**PLAN COMMISSION PC #20-016  
Hamilton Partners PUD Amendment  
703-723 W. Algonquin Rd  
Round 3**

## REVIEW ROUND 3

Project: Hamilton Partners – 703 W. Algonquin Rd. PUD Amendment

Case Number: PC 20-016

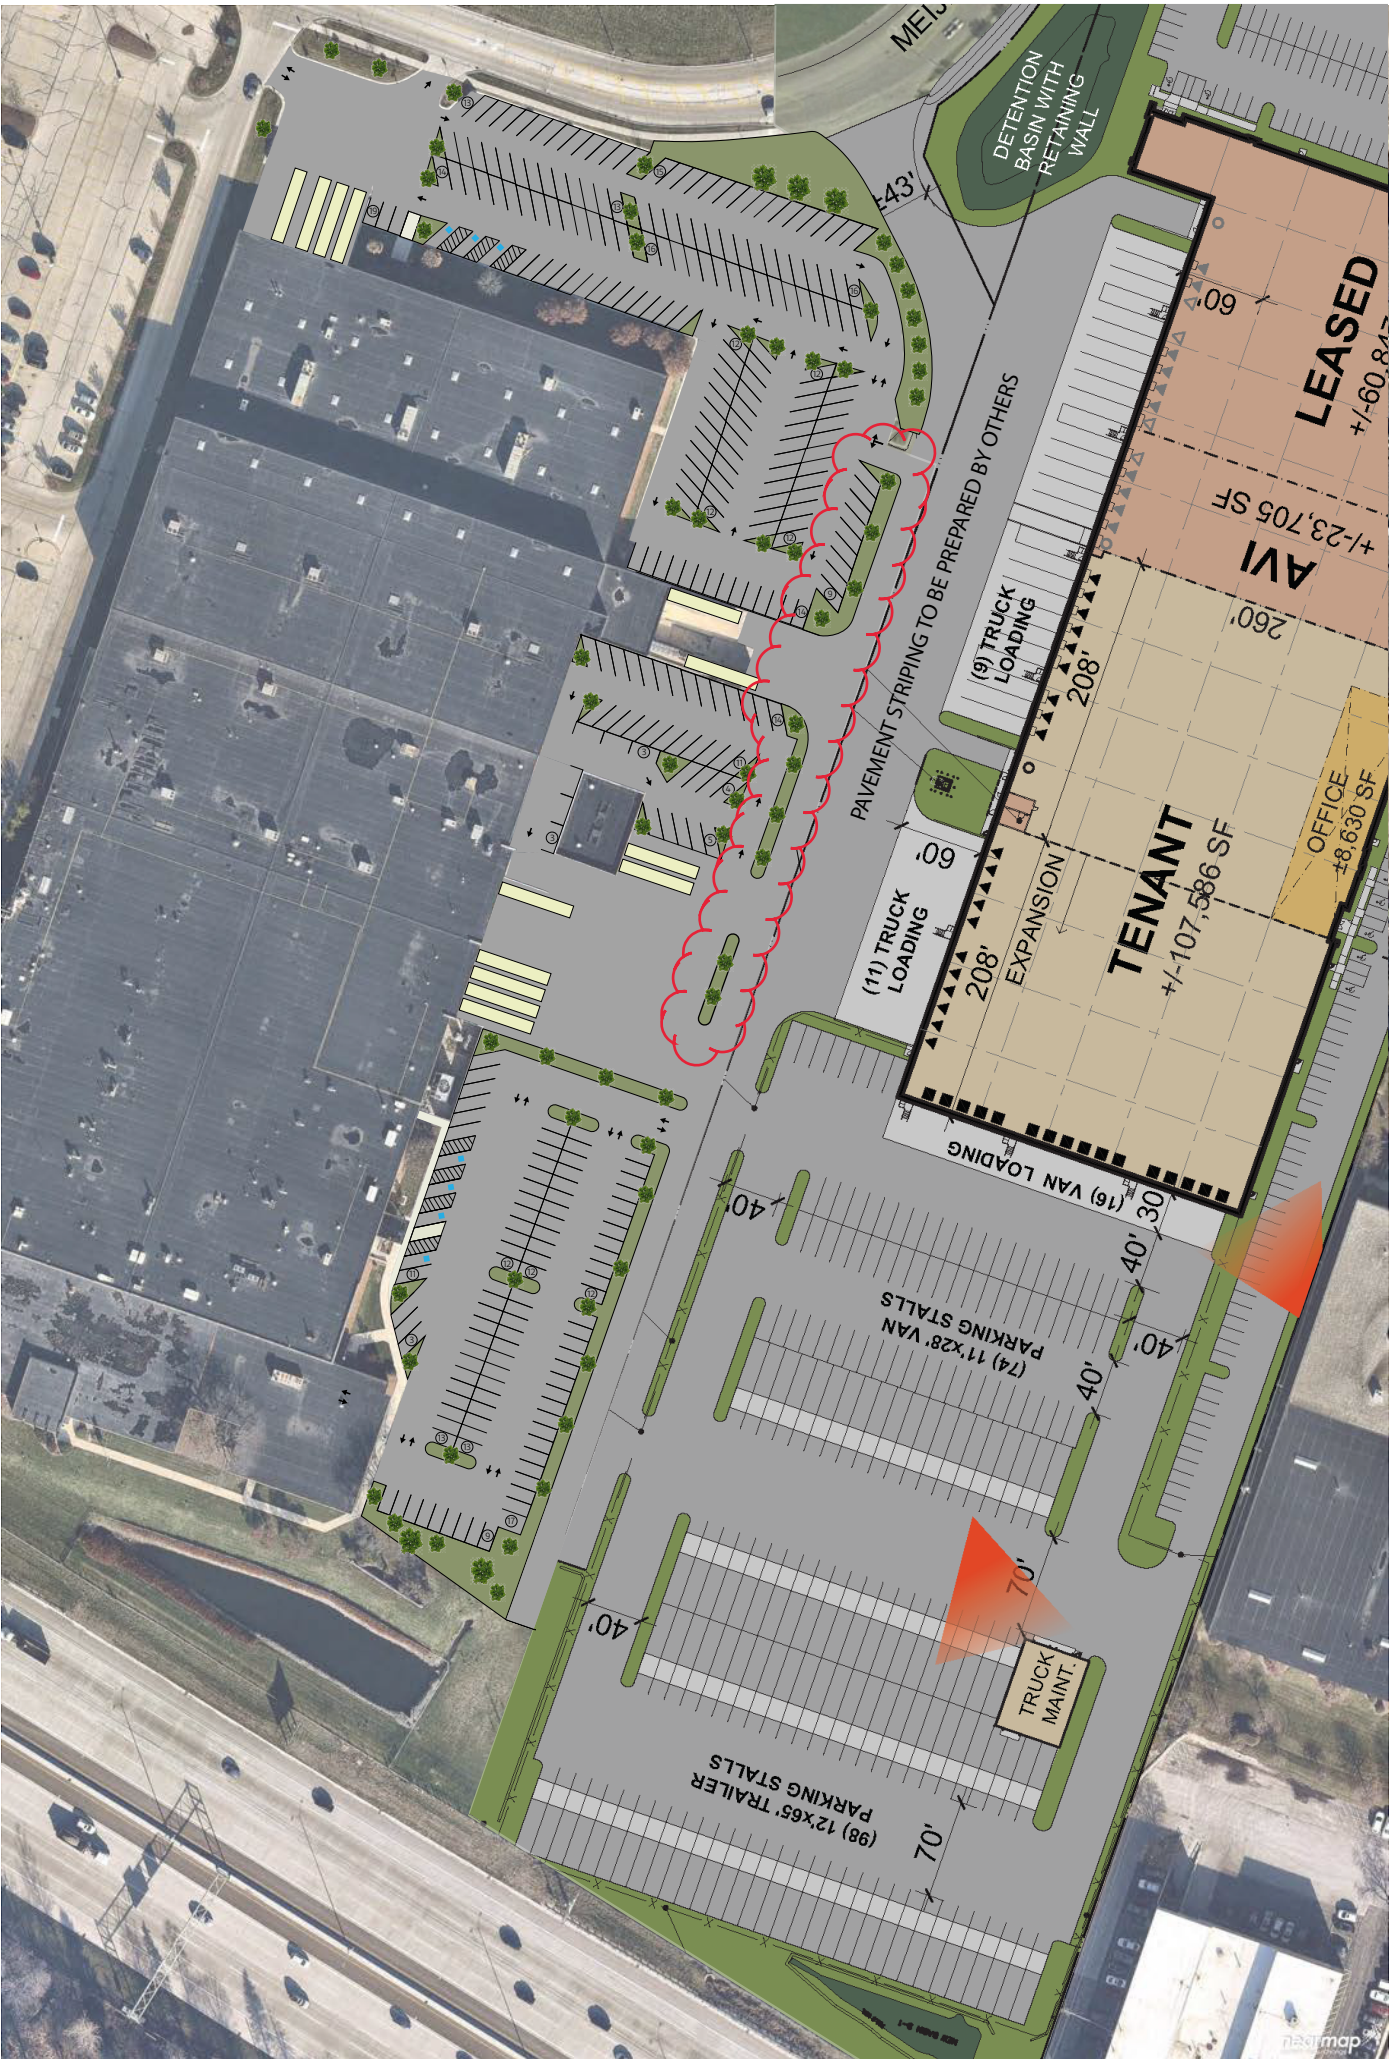
In the spirit of this condition of approval, you are encouraged to collaborate with Weber Packaging on implementation of a concept, similar to the attached, which would provide a lineal buffer along the western side of the shared access drive adjacent to the western bays (in the areas outlined in red) to prevent trucks on the subject property from encroaching into the Weber site.
